STAFF REPORT
COMMUNITY DEVELOPMENT DEPARTMENT

HEARING DATE: 6/7/2022
 TO: Mayor & City Council
 FROM: Joe Dodson, Associate Planner
 208-884-5533
 SUBJECT: H-2022-0014
 Grayson Subdivision

Request for Annexation and Zoning of 3.39 acres from RUT to the R-8 zoning district and a Preliminary Plat consisting of 15 single-family residential building lots and 3 common lots on 3.1 acres of land in the requested R-8 zoning district, by Schultz Development, LLC.

C. Landscape Plans (date: 3/9/2022)

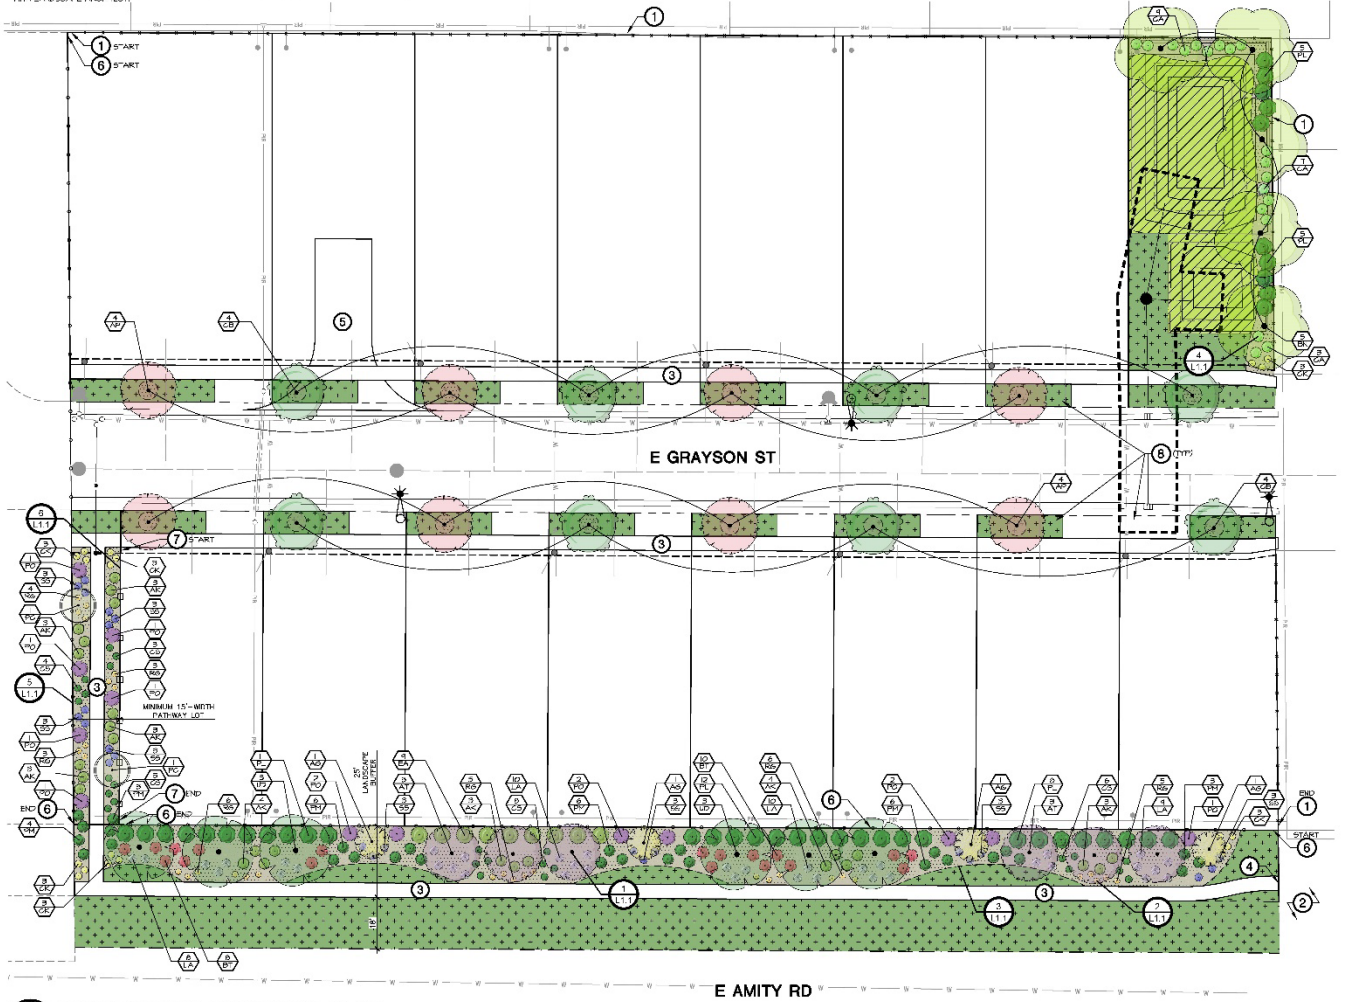
The Applicant has proposed a 5-foot wide detached sidewalk within the Amity Road street buffer which does not comply with this requirement. Therefore, Staff is including a condition of approval for the Applicant to revise the landscape plans to depict the required regional pathway within this buffer. Furthermore, this pathway should be at least four (4) feet north of the ultimate right-of-way line to allow for landscaping on both sides of the pathway and ensure the pathway is detached from the roadway and allow the 25-foot buffer to be measured from the ultimate right-of-way instead of the back of the pathway, per UDC 11-3B-7C.1a.

As noted above, the proposed 8-foot wide parkways do not appear to depict the correct number of street trees. Each parkway is approximately 420 feet long which requires a minimum of 12 trees on each side of Grayson Street. The submitted landscape plans depict 8 trees within each parkway so an additional four (4) trees are needed on each side of the street. Staff is including a condition of approval consistent with this requirement.

- a. Depict the correct number of street trees within the parkway per UDC 11-3B-7.
 - b. Add seating and a shade structure within the drainage common lot (Lot 1, Block 1).

- c. Depict the required 10-foot wide regional pathway within the Amity Road landscape buffer and place it at least four (4) feet north of the ultimate right-of-way line to allow for landscaping on both sides of the pathway and ensure the pathway is detached from the roadway and allow the 25-foot buffer to be measured from the ultimate right-of-way instead of the back of the pathway, per UDC 11-3B-7C.1a.

4. The preliminary plat included in Section VII.B, dated February 17, 2022, is approved as submitted.
5. The landscape plan included in Section VII.C, dated March 9, 2022, shall be revised as follows prior to submitting for Final Plat approval:

E. Temporary Turnaround Options – West terminus of E. Grayson Street extension

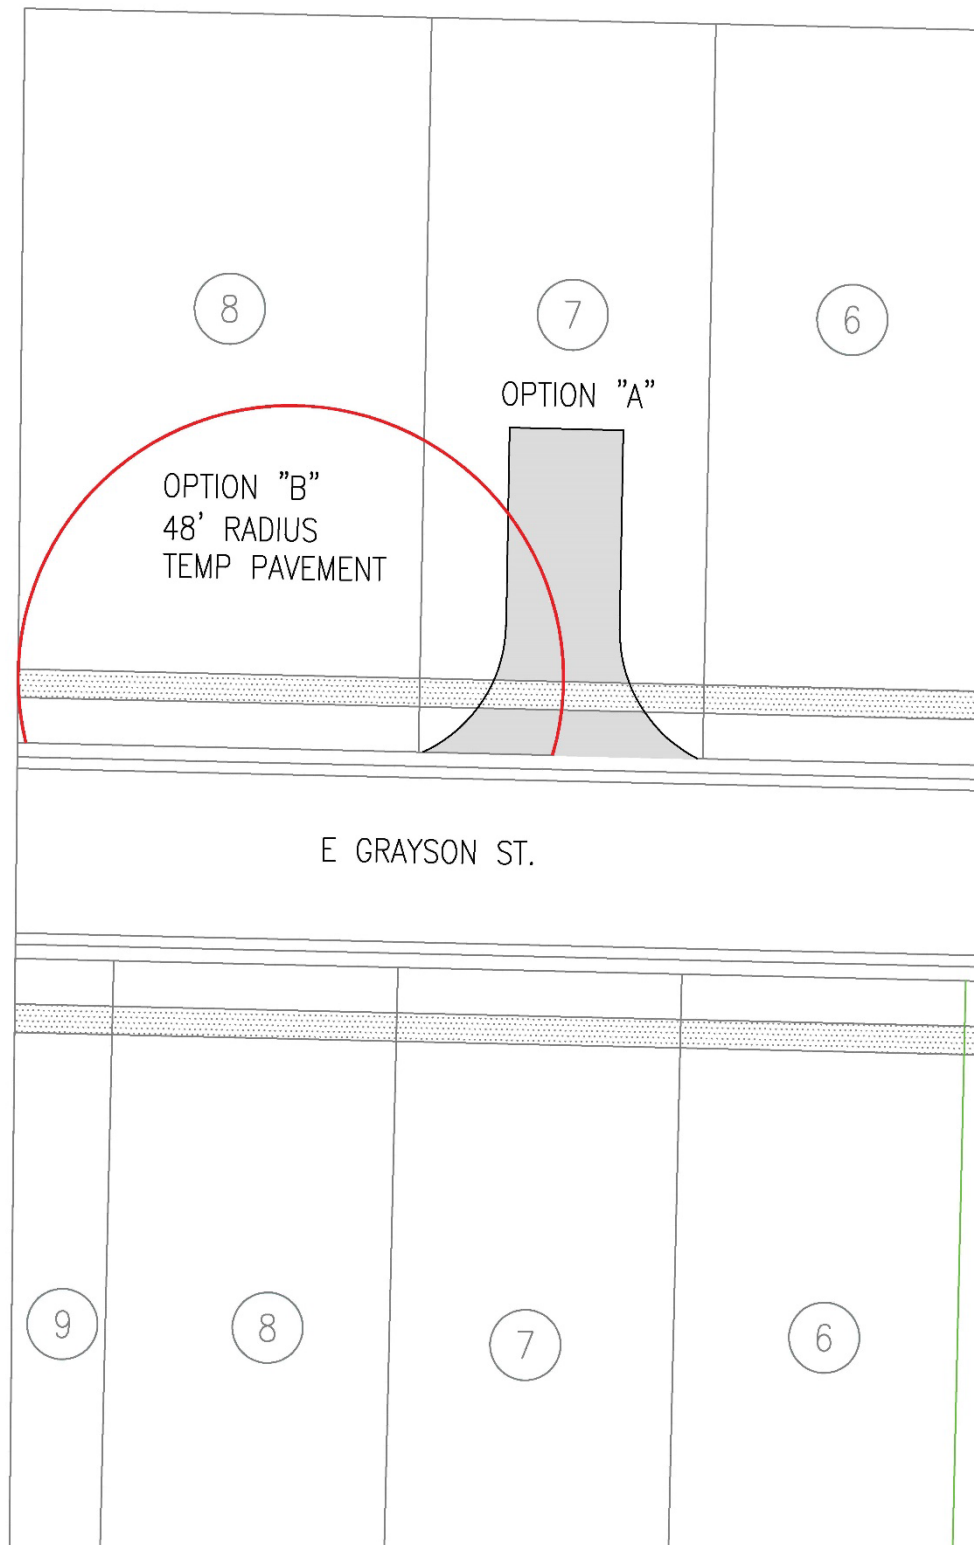
In addition to these elements, the proposed termination of the Grayson Street extension should be discussed. Specifically, this Applicant has proposed to stub Grayson to the west boundary as required by ACHD and the UDC but is showing a temporary hammerhead-type turnaround that encumbers a building lot, Lot 7, Block 1. Typically, ACHD has not allowed this type of turnaround in recent years, even on a temporary basis. The Fire Department and Planning Staff support the proposed design as it meets Fire requirements and does not make two future lots non-buildable for the near future. However, Staff anticipates ACHD will not approve this temporary turnaround. So, the Applicant has provided an exhibit showing Lots 7 & 8, Block 1 encumbered by an offset cul-de-sac as an alternative temporary turnaround should ACHD not allow the hammerhead. See snip below and Exhibit VII.E for this proposal:

Access is proposed via extension of E. Grayson Street (an existing residential local street) into the site and is proposed to terminate within the site at the west boundary for future connectivity. As discussed above, the Applicant is proposing to provide a temporary hammerhead-type turnaround instead of a temporary cul-de-sac. Staff supports this temporary turnaround design in order to save space and minimize the waste of asphalt within this development but anticipates ACHD will not approve this type of temporary turnaround. **If ACHD does not approve the hammerhead design as recommended by Staff, the applicant shall restrict Lots 7 and 8 as non-buildable lots as proposed and place a note on the final plat stating these lots will be developable with the extension of the public street.**

2. The applicant is seeking a Council waiver for E. Grayson Street to be a dead-end street greater than 500 feet in length, per UDC 11-6C-3B.4.
3. Per Exhibit VII.E attached hereto, E. Grayson Street shall terminate along the west property boundary as either a temporary cul-de-sac or hammerhead type turnaround—if a hammerhead type turnaround is approved by ACHD, Lot 7, Block 1 shall be a non-buildable lot until such time as Grayson is further extended; if a cul-de-sac turnaround is required, Lots 7 & 8, Block 1 shall be non-buildable lots until such time as Grayson is further extended.
